ADDENDUM NO. 2

Owner: University of Colorado at Boulder

Project Name: PR003039 ECCH – HVAC Mechanical Upgrades, Phase 1 of 2

Date: March 5, 2009

DOOR INFILL DETAIL

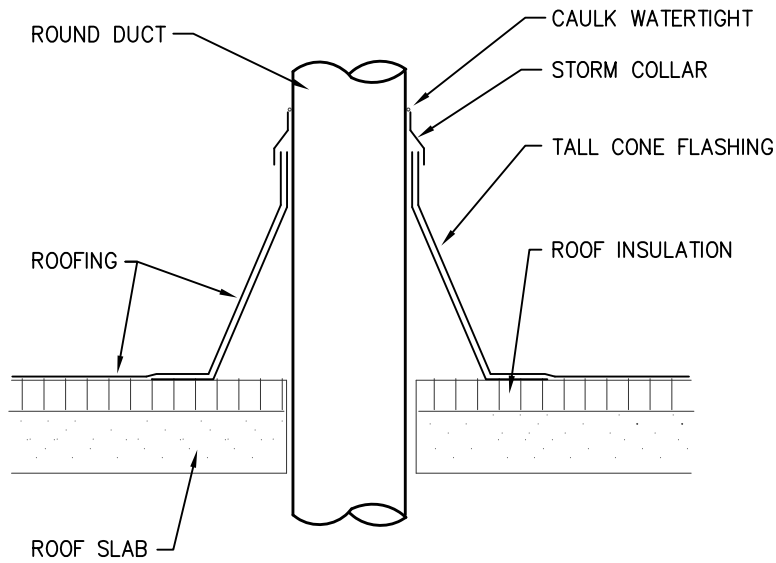
- 2.8 MD2.04, key notes #1 & #2; is there a detail for sealing the grill in the wood door and above the door in the wood transom? **Response: See "Wall Infill Detail" on sheet M1.02 and see new Door Infill detail on attached sketch MX-3.**

2.25 See attached sketches, MX-3, MX-4 and MX-5, for required details.

ROUND DUCT ROOF PENETRATION DETAIL

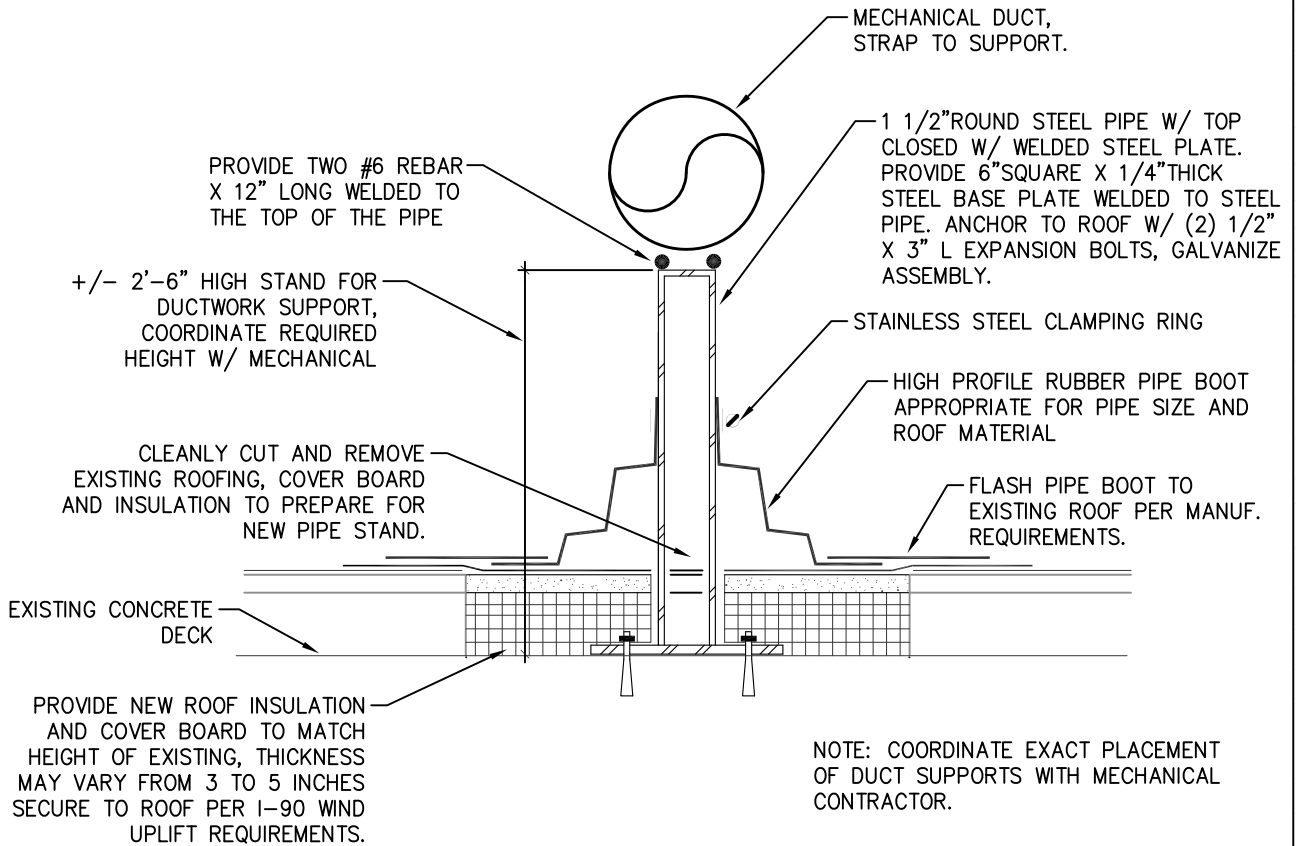
- 2.3 Is the fan curb to be abandoned in place with a curb cap? **Response: Yes and sealed water tight.**
- 2.4 Please provide roofing details for new roof penetration shown on M2.05. **Response: See attached detail on sketches MX-4 and 5.**
